Test of force controlled yielding seats to draft GTR head restraint dynamic test

Head Restraint Informal Working Group Meeting
January 23-26, 2006
BASt, Köln, Germany

Autoliv draft GTR dynamic test evaluation

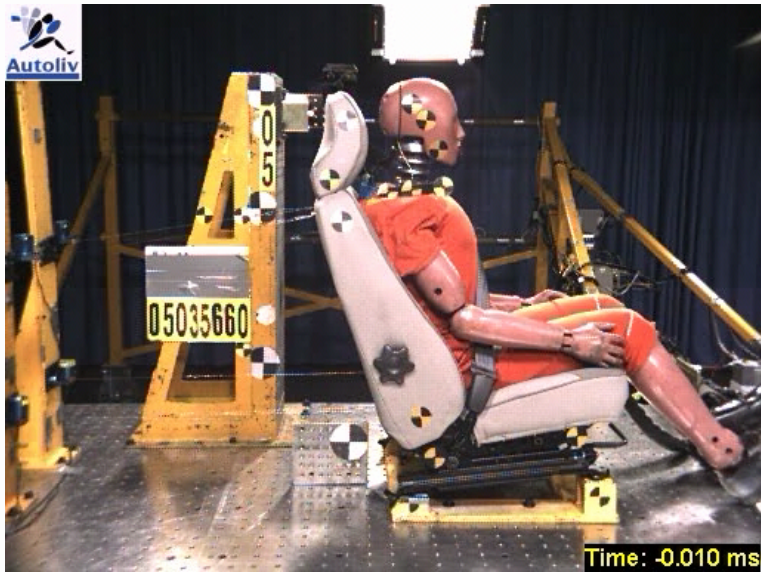
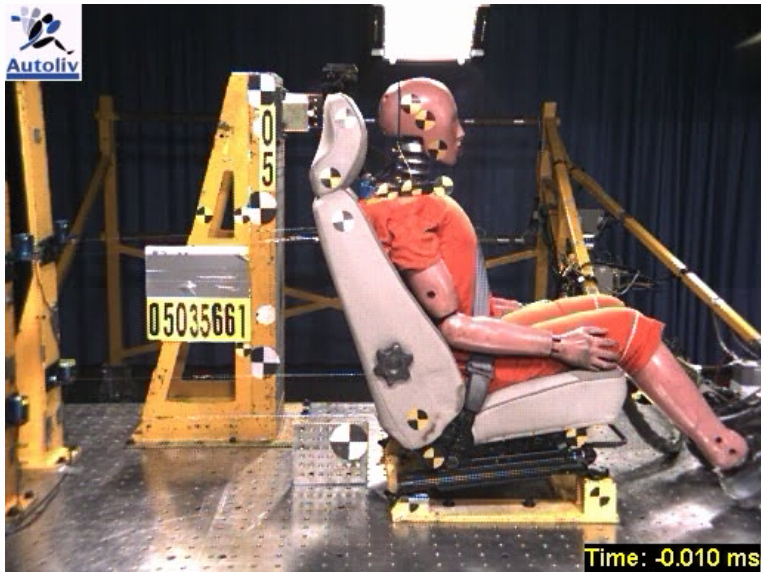
Volvo Whips-R test results are excellent when BioRID and BioRID performance criteria are used

When tested with Hybrid III, the head-torso rotation is reduced, but exceeds 12 degrees

Head-torso rotation risk curve

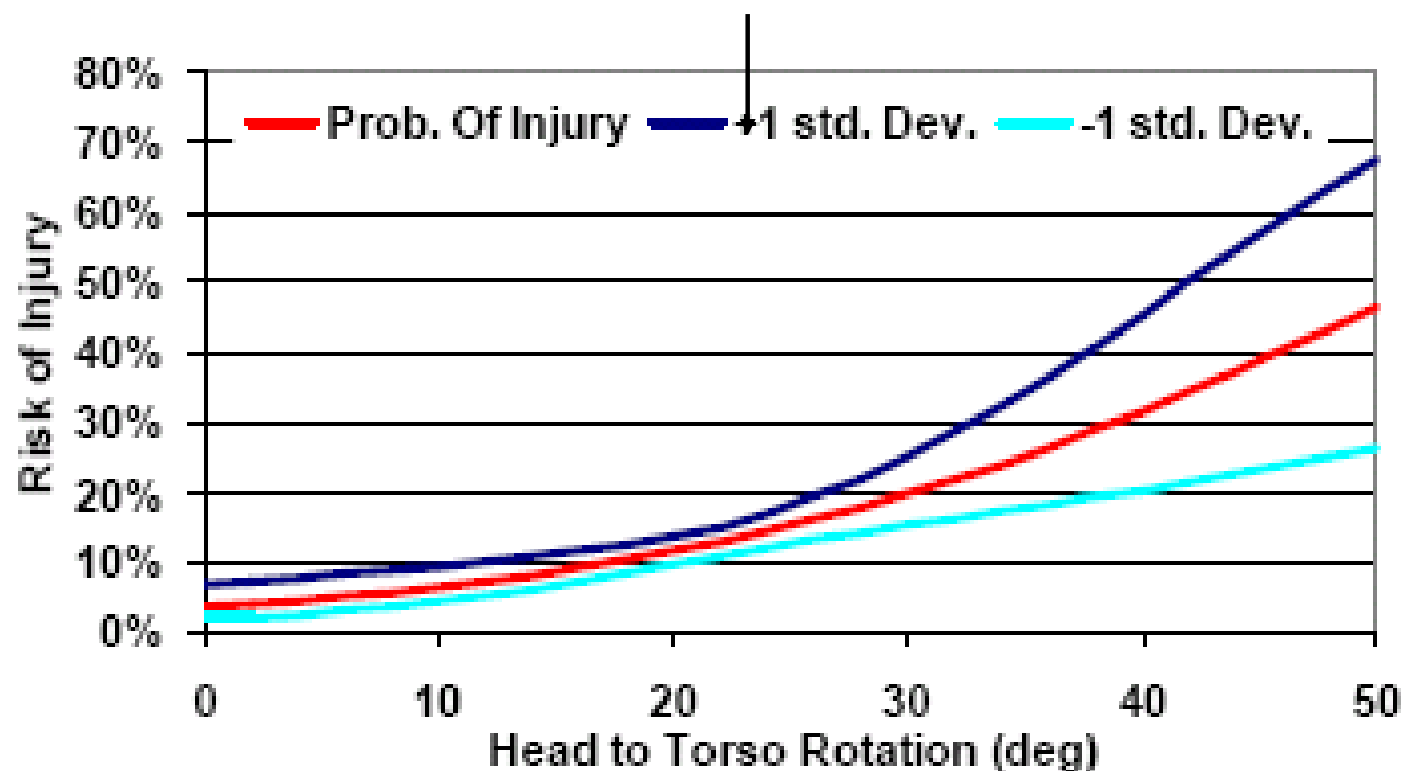
The FMVSS202 risk curve is based on two (2) observations. No force controlled yielding systems were taken into account.

Proposed GTR head-torso rotation **risk curve** is based on only two observations of claim frequency where sample data- Δv median is only 10 km/h
